MURPHY PLANNING AND ZONING COMMISSION AGENDA  
REGULAR PLANNING AND ZONING COMMISSION MEETING  
AUGUST 25, 2014 AT 6:00 PM, CITY HALL, COUNCIL CHAMBERS  
206 NORTH MURPHY ROAD  
MURPHY, TEXAS 75094

Consider and/or act on the application of McBirney 544 Joint Venture requesting approval of a site plan, landscape plan, building elevations, signage and construction plat for The Learning Experience on property zoned PD 09-12-823.

# THE LEARNING EXPERIENCE SITE DEVELOPMENT PLANS

THE LEARNING EXPERIENCE  
SWC OF VILLAGE DRIVE &  
BRAND ROAD  
CITY OF MURPHY, TEXAS

**SITE PLAN**  
**MURPHY VILLAGE ADDITION,**  
**BLOCK B, LOT 5**  
1.556 ACRES OUT OF  
JAMES MAXWELL SURVEY, ABSTRACT NO.580  
CITY OF MURPHY, COLLIN COUNTY, TEXAS  
DATE:07/24/2014

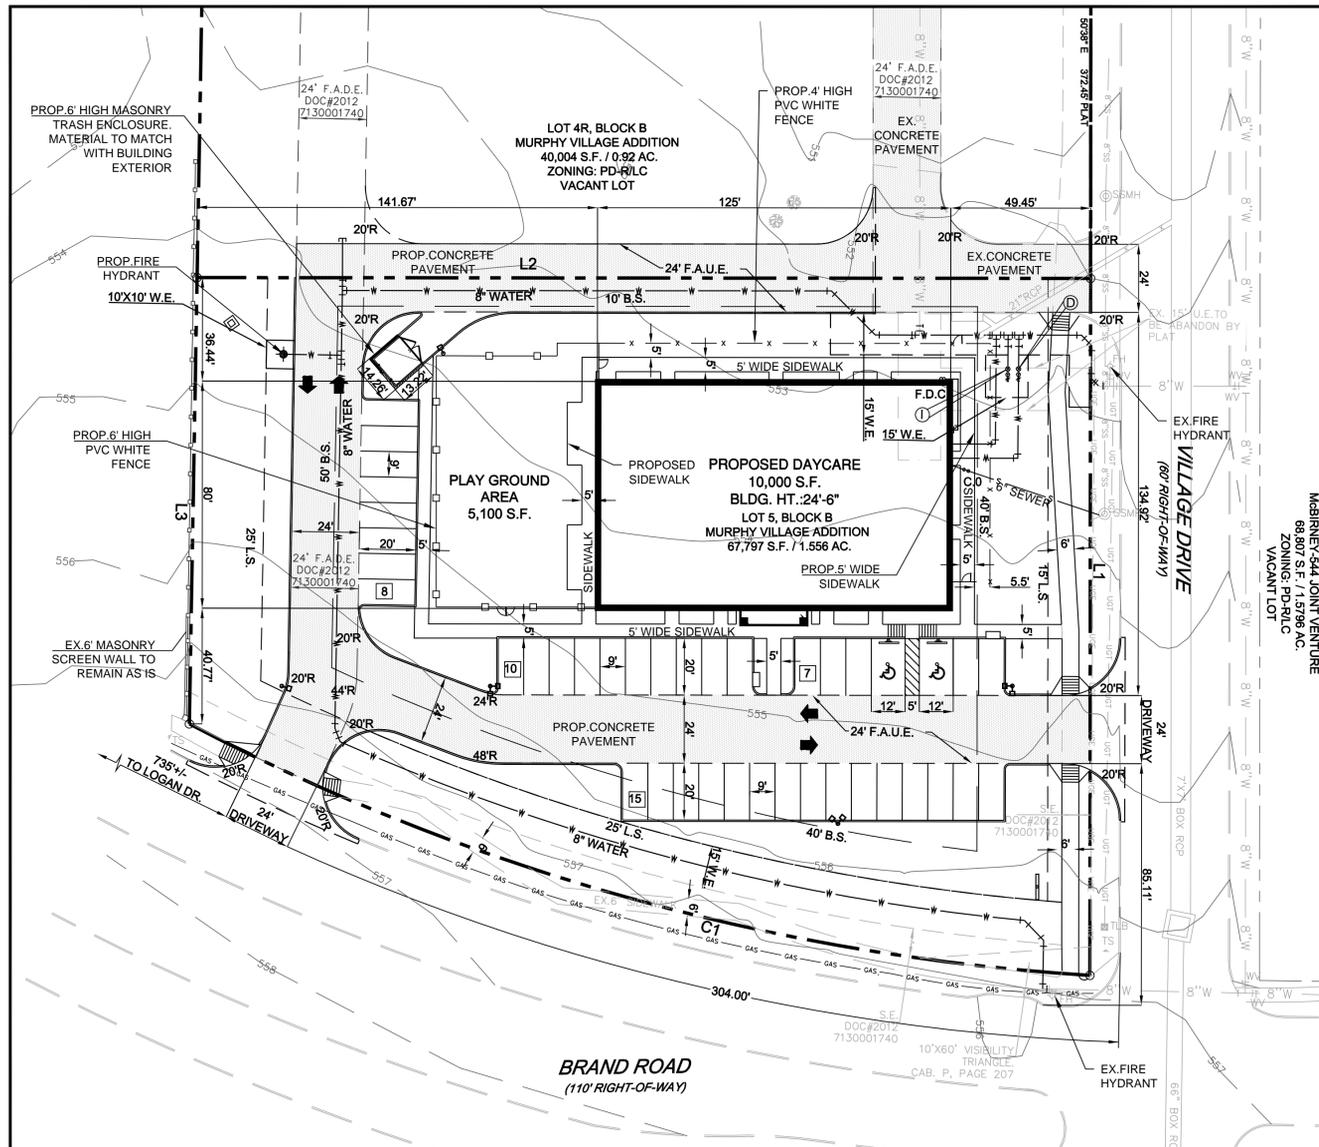
The proposed site plan has been reviewed by staff and meets the requirements as set forth by the Planned Development District and the Code of Ordinances including:

*Parking* – The parking ratio as specified in Section 86-706(17) of the City of Murphy Code of Ordinances is one space per ten pupils, plus one space per teacher, plus one space for each bus or van stored on the property. At this ratio, 40 parking spaces are required and 40 parking spaces are provided. This factors 19 spaces for 195 students and 20 spaces for 20 teachers and 1 space for a bus.

*Setbacks* – All building setbacks as detailed within the Planned Development District have been met on this site; including building setbacks from Brand and Village Roads (40' minimum), side property lines (10' minimum) and the abutting residential district (50' minimum).

*Sidewalks* – Sidewalks along Brand Road and Village Road shall be 6 feet in width. There is an existing 6 foot sidewalk along Brand Road adjacent to this development. The current sidewalk along Village Road is five feet wide and with this development will be widened to the required 6 feet and is shown on the site plan. This Planned Development District requirement has been met.

*Height regulations* - Maximum height regulations are as follows: three stories or 45 feet for the main building, except maximum height shall be 25 feet for any portion of a building that is located within 100 feet of a residential zoning district. This site plan shows a building height of 24'6" and is within the allowed height requirements.

**A-5.1**

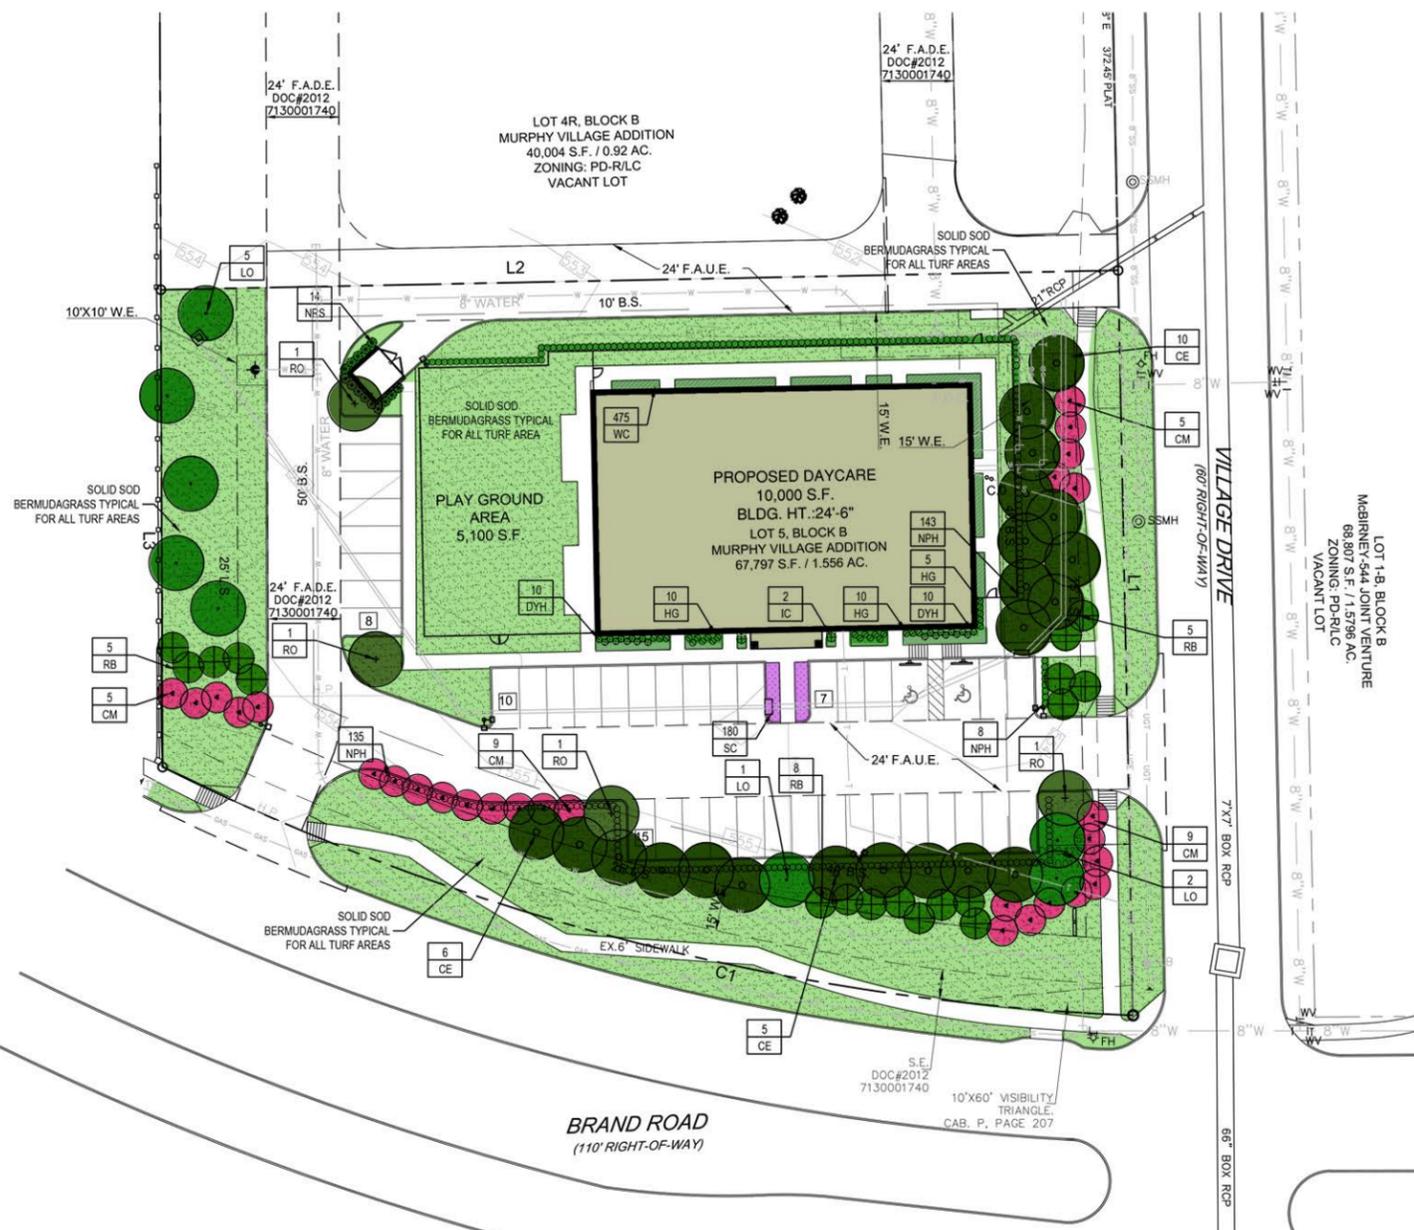
The proposed building elevation and materials meet requirements as set forth by the Planned Development District including:

- The use of at least two masonry materials in addition to glass is required and provided and the materials used are acceptable based on the City of Murphy Code of Ordinances exterior construction and design material standards and within the Planned Development District Ordinance.
- As stated above, the maximum height shall be 25 feet for any portion of a building that is located within 100 feet of a residential zoning district. This building elevation as presented shows a building height of 24'6" and is within the allowed height requirements.

LANDSCAPE PLAN	PROJECT NO:	DATE:	DRAWN BY:	CHECKED BY:
L.1	018-14	06/18/2014	CT	CT
SHEET #	REVISION #			
L.1	1

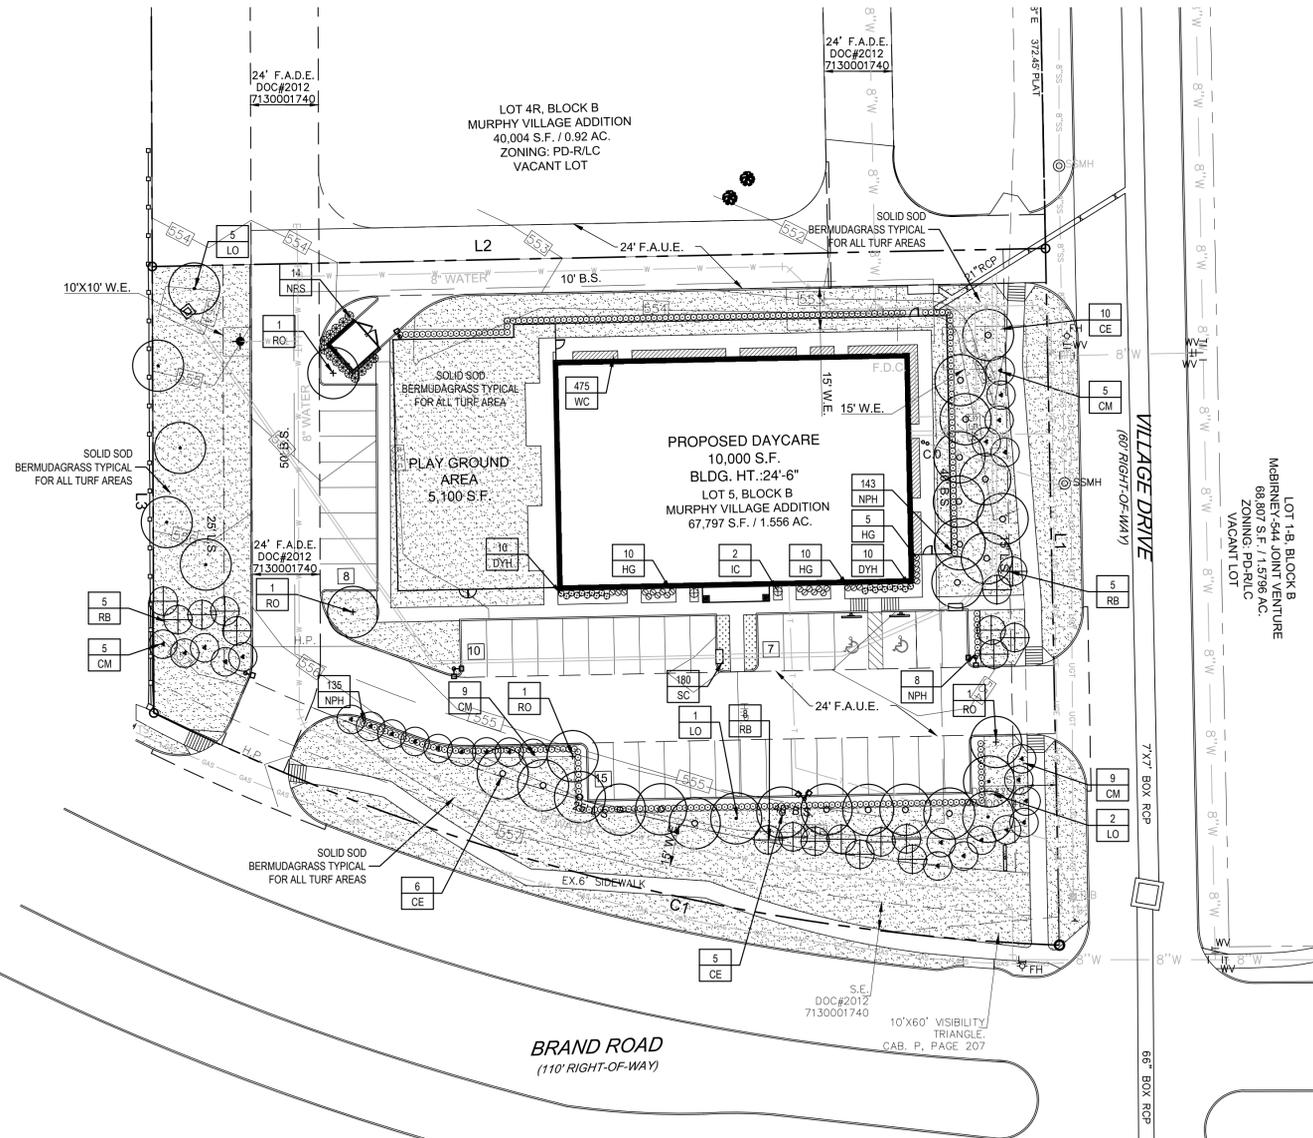
The proposed landscape and materials used have met requirement standards including landscape setbacks as detailed within the Planned Development District.

**MURPHY VILLAGE ADDITION  
BLOCK B LOT 5**  
(67,797 S.F. OR 1.556 ACRES)  
ZONE PD#09-12-823

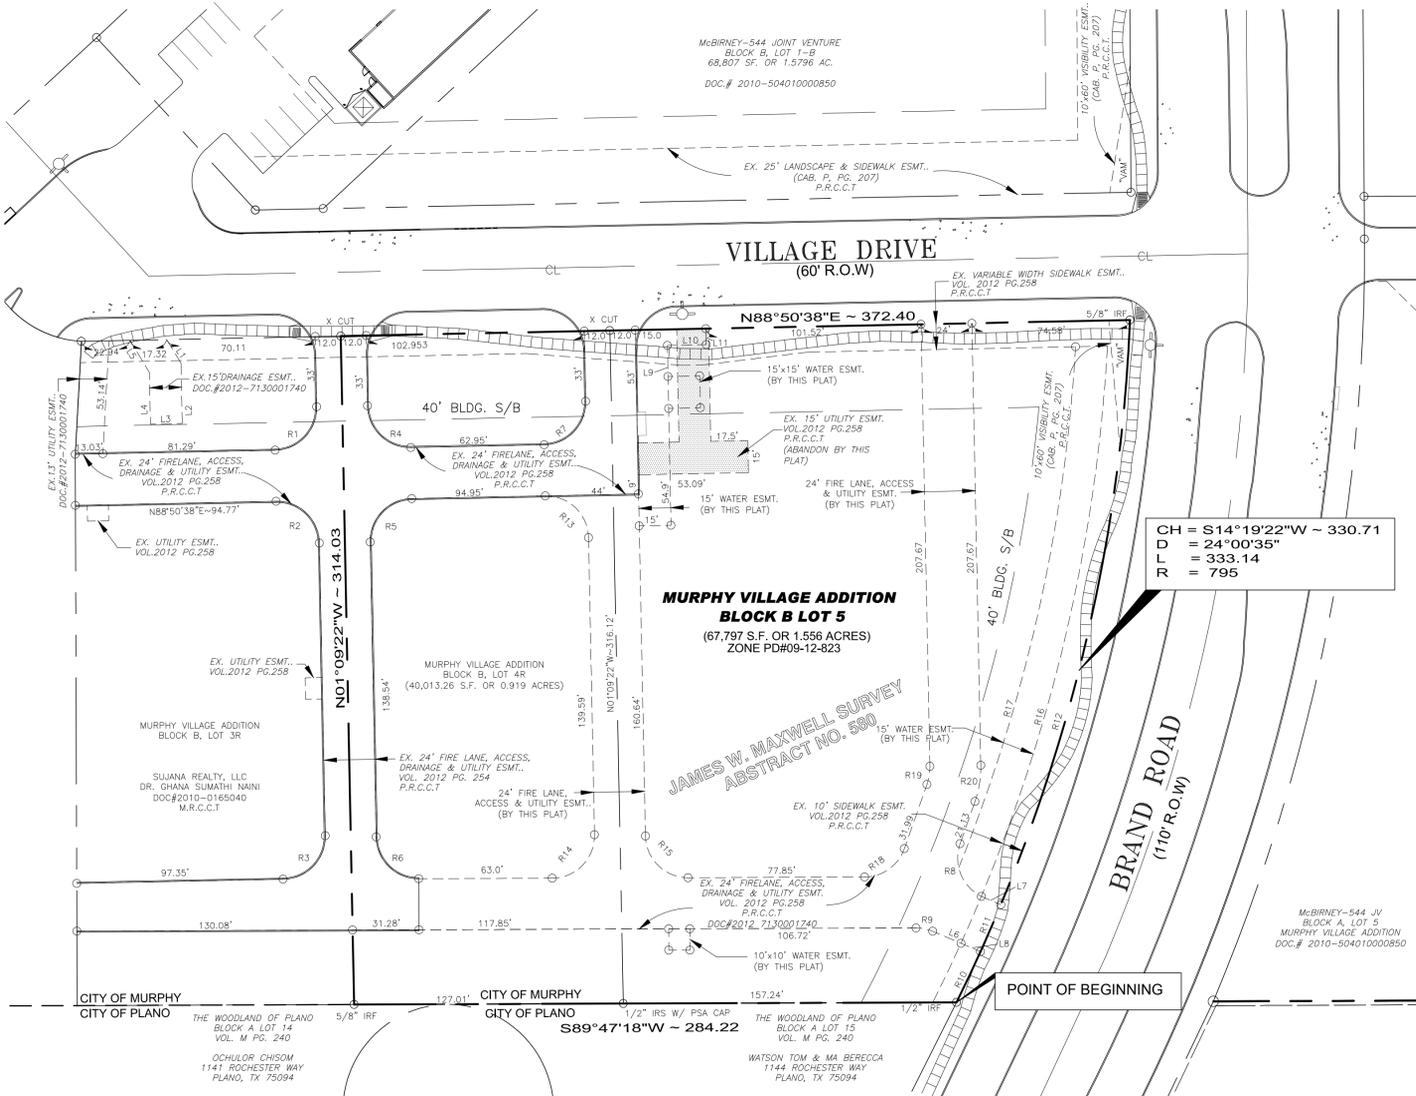
The construction plat meets requirements (see notations below).

After public improvements have been completed and accepted by the City of Murphy, a re-plat of a final plat will be submitted for approval to allow for two separate tracts on record; this property to be developed by way of this consideration item and the property to the west.
